Remarks

Annotation Showing Changes

FIG. 1

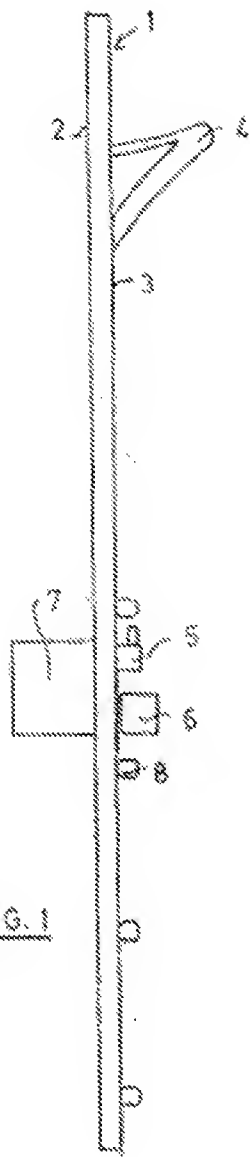
Align figure
to sheet

FIG. 2

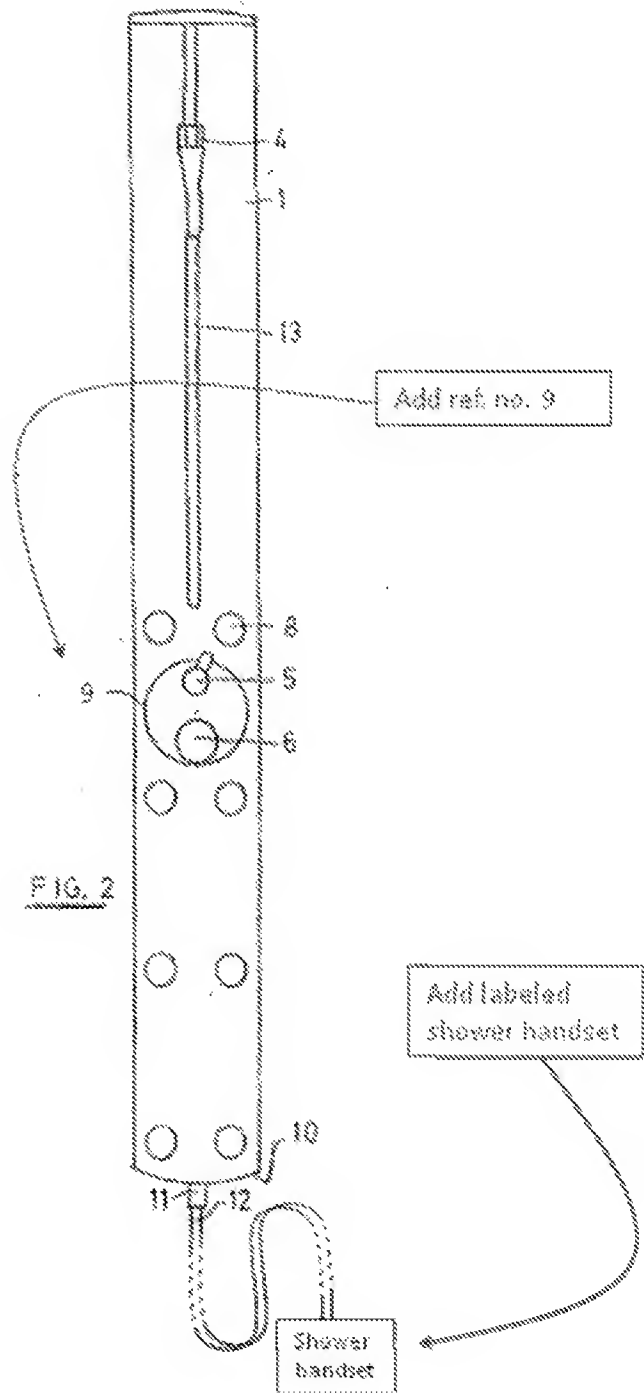
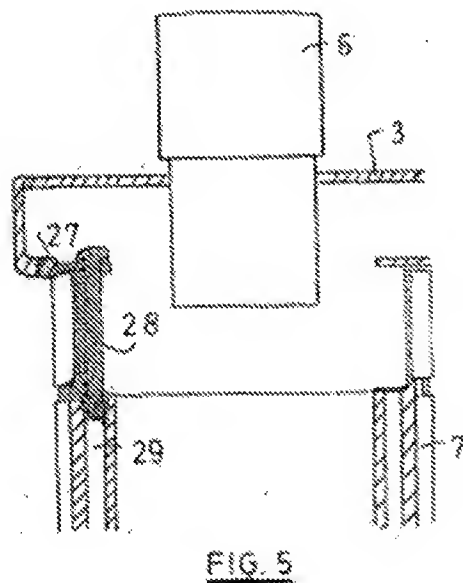
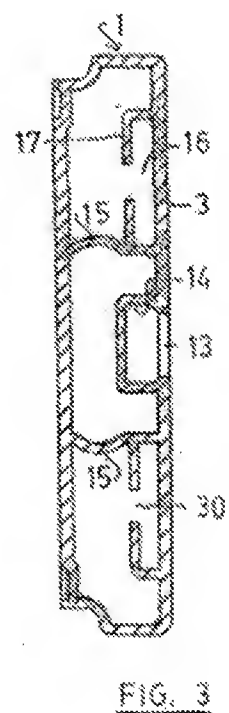
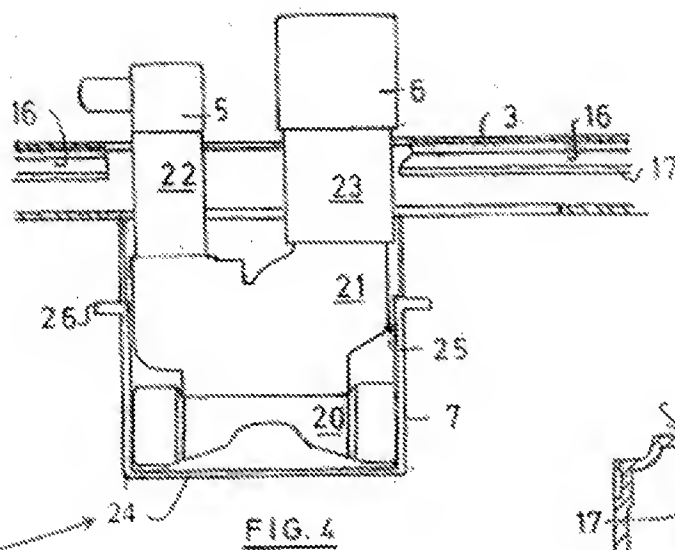
Applicant proposed to insert a schematically illustrated shower handset as a labelled box in Fig. 2, on the water deliver path defined by the hose 12 consistent with paragraph [0032] (see page 5, lines 16-20). The handset is one of plural alternative discharges, another being the shower head(s) 8, for example. Additionally, the disclosure provides for other hoses for water delivery, including within the profile, such as a hose coupled with the hose clamp fittings shown in Fig. 7 and described at paragraph [0043] (see page 8, lines 4-10).

FIG. 6

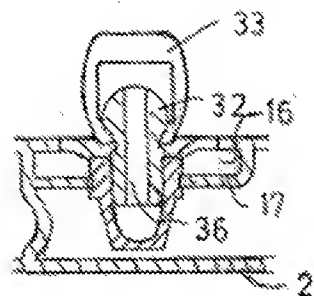
Align figure
to sheet

Add ref. no. 24

Align figure
to sheet
